RE: Docket Number FAA-2019-0853
Product Identifier 2019-CE036-AD

November 7, 2019

(left) Figure 1

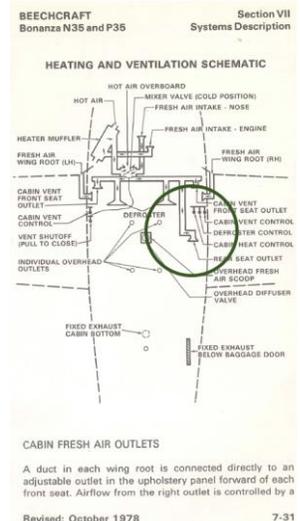
Excerpt from the Beech Pilot's Operating Handbook for K35 and M35 Bonanzas. The heater system is described as having only one aft outlet behind the right front seat. The POH illustration confirms this single aft outlet on the back side of the forward spar carry-through. The K35 and M35 do not have the extended heater duct that travels over the right aileron cable and turnbuckle, so the K35 and M35 are not affected by the issue addressed in AD 2019-21-08.

To prevent owners of K35, M35, N35 and P35 Bonanzas from being required to complete this inspection that addresses an issue that does not apply to these types, the ABS Air Safety Foundation requests that FAA revise and reissue the NPRM and Final Rule AD to remove these models from the list of affected aircraft before the November 22, 2019 effective date.
